# MIL "ON" DTC P0430

YEAR(S)	MODEL(S)	ADDITIONAL INFORMATION
2010	RX450H

### SUPERSESSION NOTICE

The information contained in this bulletin supersedes SB No. L-SB-0127-11.

Figure 1.

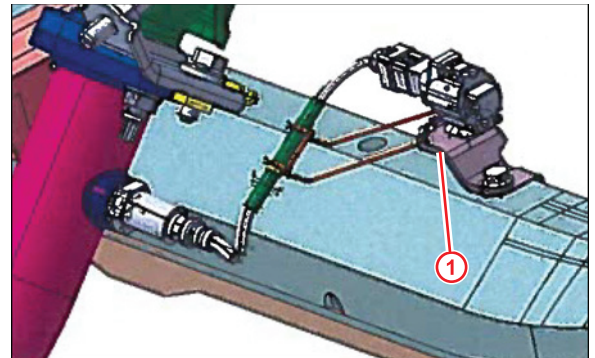
1. Using Techstream, verify DTC P0430 (Catalyst System Efficiency Below Threshold [Bank 2]) is present.
2. Inspect the O2 B2S2 voltage and the O2 B2S2 Impedance.
3. If the O2 B2S2 voltage is 1.275 Volts or the O2 Impedance B2S2 is over 300 ohms with the engine at normal operating temperature replace the B2 O2 sensor and wire harness clamp.

1 Wire Harness Clamp
